Sheet: /
File: pink0.sch
Title:
Size: A4
Date:
Rev:
KiCad E.D.A. kicad 4.0.6
Id: 1/1

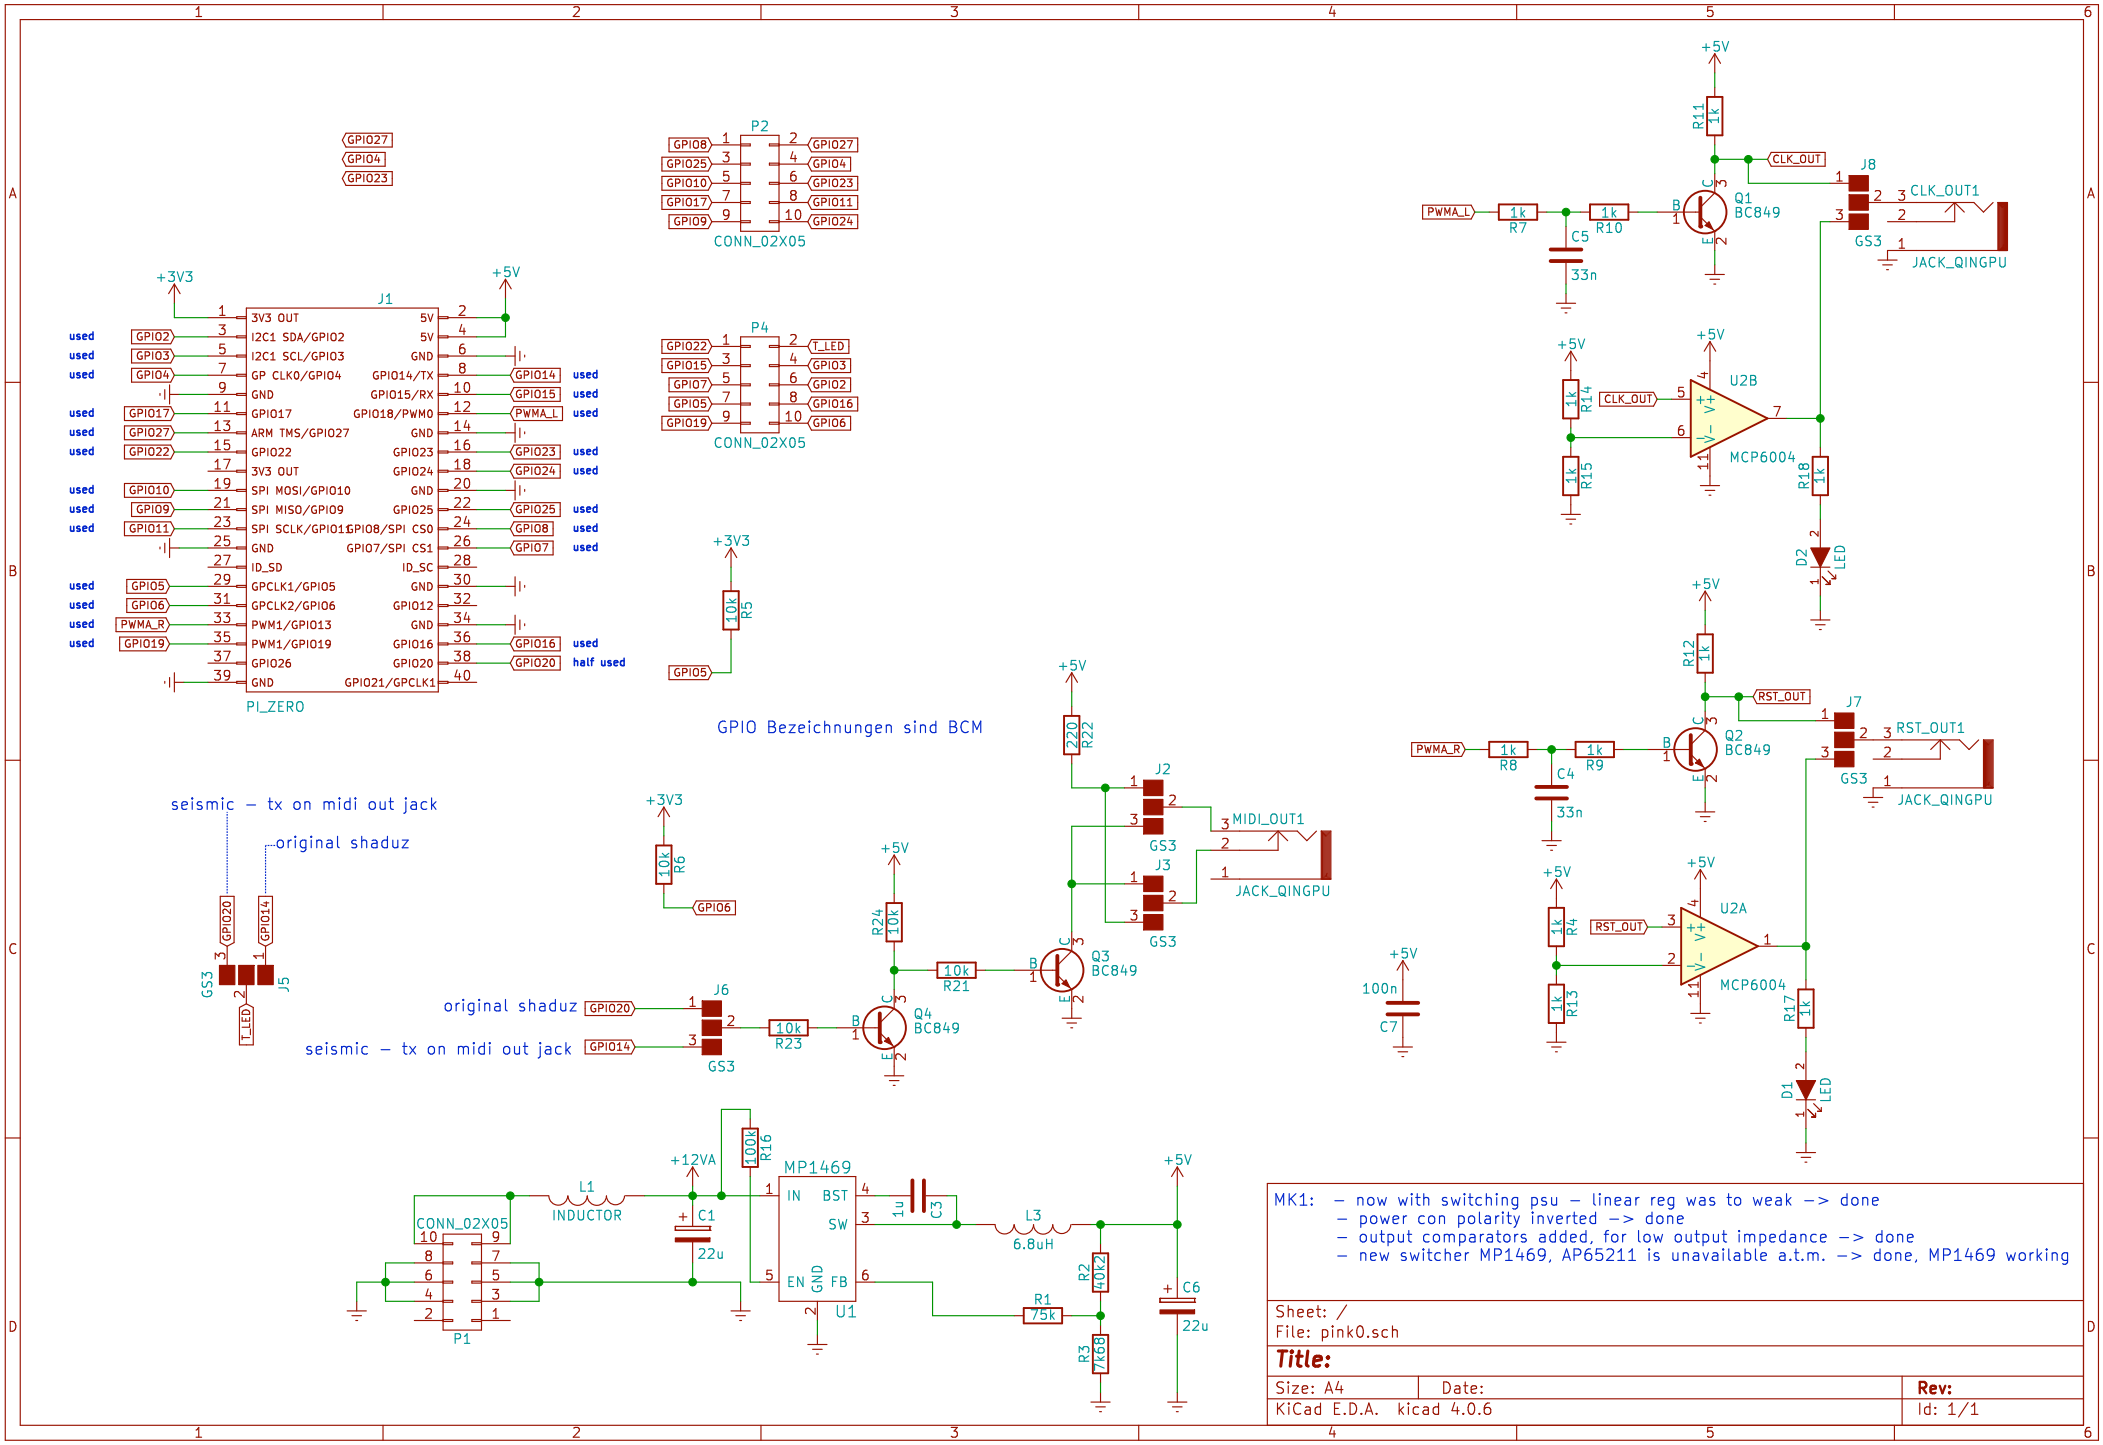
GPIO27
GPIO4
GPIO23
P2
CONN_02X05
P4
CONN_02X05
J1
PI_ZERO
3V3 OUT
I2C1 SDA/GPIO2
I2C1 SCL/GPIO3
GP CLK0/GPIO4
GPIO17
ARM TMS/GPIO27
GPIO22
SPI MOSI/GPIO10
SPI MISO/GPIO9
SPI SCLK/GPIO11
ID_SD
GPCLK1/GPIO5
GPCLK2/GPIO6
PWM1/GPIO13
PWM1/GPIO19
GPIO26
GPIO14/TX
GPIO15/RX
GPIO18/PWM0
GPIO23
GPIO24
GPIO25
GPIO8/SPI CS0
GPIO7/SPI CS1
ID_SC
GPIO12
GPIO16
GPIO20
GPIO21/GPCLK1
GPIO Bezeichnungen sind BCM
seismic – tx on midi out jack
original shaduz
J5
GS3
J6
J2
J3
MIDI_OUT1
JACK_QINGPU
Q3 BC849
Q4 BC849
R21 10k
R23 10k
R24 10k
R22 220
R5 10k
R6 10k
MP1469
U1
L1 INDUCTOR
L3 6.8uH
C1 22u
C3 1u
C6 22u
R1 75k
R2 40k2
R3 7k68
R16 100k
CONN_02X05
P1
Q1 BC849
Q2 BC849
J8
J7
CLK_OUT1
RST_OUT1
U2B
U2A
MCP6004
R7 1k
R10 1k
R11 1k
R8 1k
R9 1k
R12 1k
R14 1k
R15 1k
R18 1k
R4 1k
R13 1k
R17 1k
C5 33n
C4 33n
C7 100n
D2 LED
D1 LED
MK1: – now with switching psu – linear reg was to weak –> done
– power con polarity inverted –> done
– output comparators added, for low output impedance –> done
– new switcher MP1469, AP65211 is unavailable a.t.m. –> done, MP1469 working
